# Access Compliance Report

## Public Rights-of-Way

### (Curb Ramps)

Intersection ID: 10146	Main Street: TUCKASEEGEE_RD	Cross Street: YAHTZEE_LN	Location: NW
ADA ID: B7F3D85BC3F8	Ramp Type: Perp	Initial Pass/Fail: Fail	Overall Compliance: No
Severity Score: 21.25			
Codes/Mitigation Info/Possible Solution		Field Measurements/Component Compliance

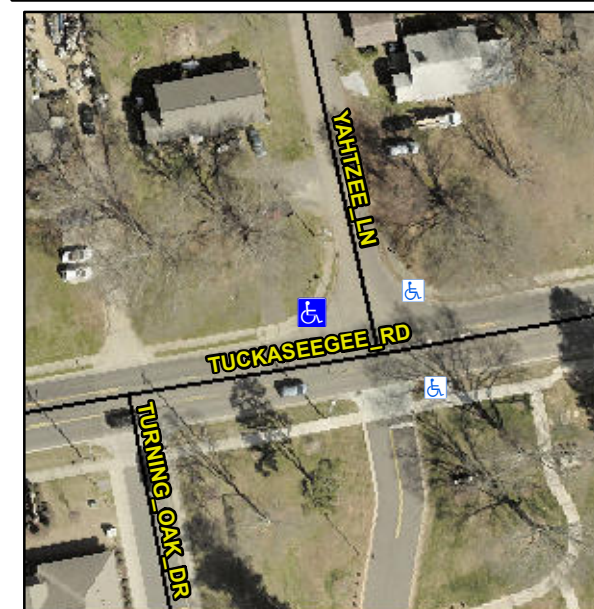
**Not Found, R304.5.1, R304.2.2**

Compliance	Description	Data	Compliance	Description	Data
N/A	Ramp Length (in)	84.0	No	Ramp Slope (%)	8.7
No	Ramp Width (in)	39.0	Yes	Ramp XSlope (%)	0.2
N/A	Flare Type LT	N/A	N/A	Flare Type RT	N/A
N/A	Flare Slope LT (%)	N/A	N/A	Flare Slope RT (%)	N/A
N/A	Flare Traversable LT?	N/A	N/A	Flare Traversable RT?	N/A
N/A	Landing Length (in)	N/A	N/A	DWS Provided?	N/A
N/A	Landing Width (in)	N/A	N/A	DWS Contrast?	N/A
N/A	Landing Slope (%)	N/A	N/A	DWS Length (in)	N/A
N/A	Landing X Slope (%)	N/A	N/A	DWS Full Width?	N/A
N/A	Landing Curb? (Y/N)	N/A	N/A	DWS Offset (in)	N/A
N/A	Shared Landing?	N/A			
N/A	Gutter Ponding?	Yes	N/A	Gutter Slope (%)	N/A
N/A	Gutter Lip Ht (in)	N/A	N/A	Gutter X Slope (%)	N/A
N/A	Painted X Walk1?	No	N/A	Painted X Walk2?	N/A
	X Walk 1 Direction	To E		X Walk 2 Direction	N/A
N/A	X Walk 1 Width (in)	N/A	N/A	X Walk 2 Width (in)	N/A
	X Walk 1 Slope (%)	3.0		X Walk 2 Slope (%)	N/A
	X Walk 1 X Slope (%)	0.7		X Walk 2 X Slope (%)	N/A

**Remove & Replace Entire Ramp.**
